PCN# : P69FAAB
Issue Date : Sep. 27, 2016

Information Only Notification

FDMQ8205		
----------	--	--

Figure 4. Normalized On Resistance vs. Junction Temperature

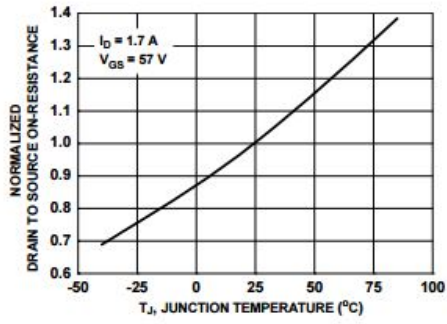
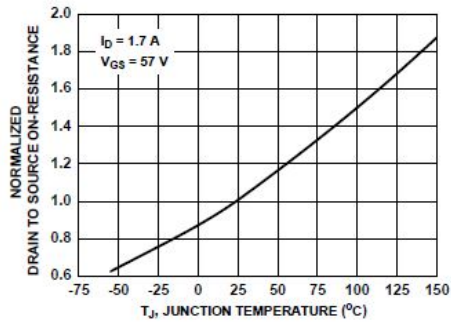
1. Absolute Maximum Ratings - Operating Temperature -40C to 85C (page 4)
2. Recommended Operating Conditions (Page 5)
3. Note 5 does not exist (Page 5)
4. Figures 4-12 has 85C as the max temp.
5. Figures 6 and 9 (Igss vs Vgs) - x-axis from 60V
6. Absolute Max Ratings : Pulsed Input at 46 A max (page 4)
7. Absolute Max Ratings : Power Dissipation (PD) 1.2W/0.38W. (page 4)
8. Features Section (Page 1)
 - "Low Power Loss GreenBridge™ Replaced With Diode Bridge"
 - "Low rDS(on) MOSFETs"

"Backfeed Voltage can not be guaranteed for junction temperature in excess of 85°C.
See VBF in Electrical Characteristics Table."
4. Changed Figures 4-12 to include 125C data points
5. Figures 6 and 9 (Igss vs Vgs) - x-axis updated to 70V .
6. Absolute Max Ratings : Pulsed Input updated to 58 A max
(due to Tjmax changed to 150C from 85C.)
7. Absolute Max Ratings : updated Power Dissipation (PD) to 2.5W/0.78W
(due to Tjmax changed to 150C from 85C.)
8. Features updated to
 - "Low Power Loss GreenBridge™ Replaces Diode Bridge".
 - "Low rDS(on) 80V Rated MOSFETs"
